ORDER NO. MD0512460S2

Service Manual

SA-AK630E / SA-AK630EB / SA-AK630EG

Top Cabinet change (Additional Information)
Please file and use this supplement manual together with the service manual for Model No. [SA-AK630E/EB/EG-S, Order No. MD0503064C2] & [SA-AK630EB-K, Order No. MD0505216S2].

2.1. Cabinet Parts Location (Additional Information)

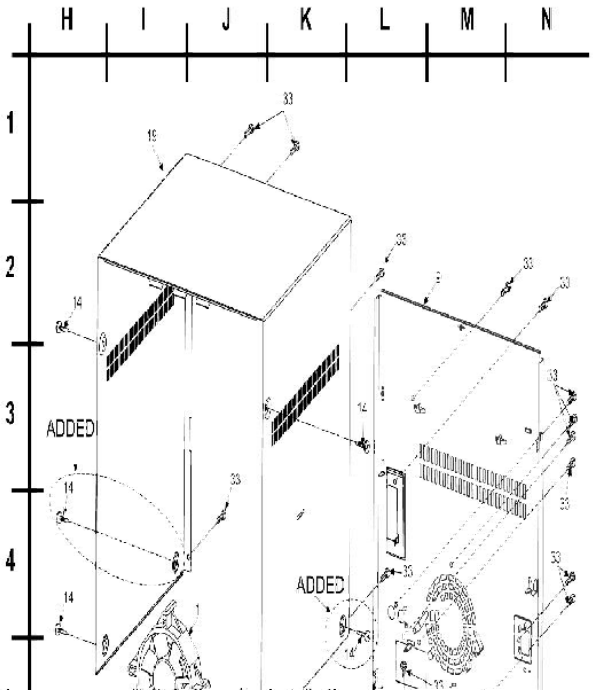
During the replacement of the top cabinet for the mentioned models, the below rules of compatibility (Table 1) must be followed & parts must be replaced correctly. This is mainly due to top cabinet specification change (additional of one screw hole) for improvements.

- When replacing the new top cabinet, ensure that the NEW bottom chassis must also be changed together at the same time (Refer to Table 1).

- Do not interchange the parts.

With reference to page 101 (section 23.3.1) of the original service manual for SA-AK630E/EB/EG-S. The cabinet parts loctaion below is for the new implementation.

Ref. No.	Part No.	Part Name & Description	Remarks
		CABINET AND CHASSIS	
19	RKMX0105-S1	TOP CABINET	[M]

Notes : Refer to Table 1 for compatibility of top cabinet & bottom chassis.
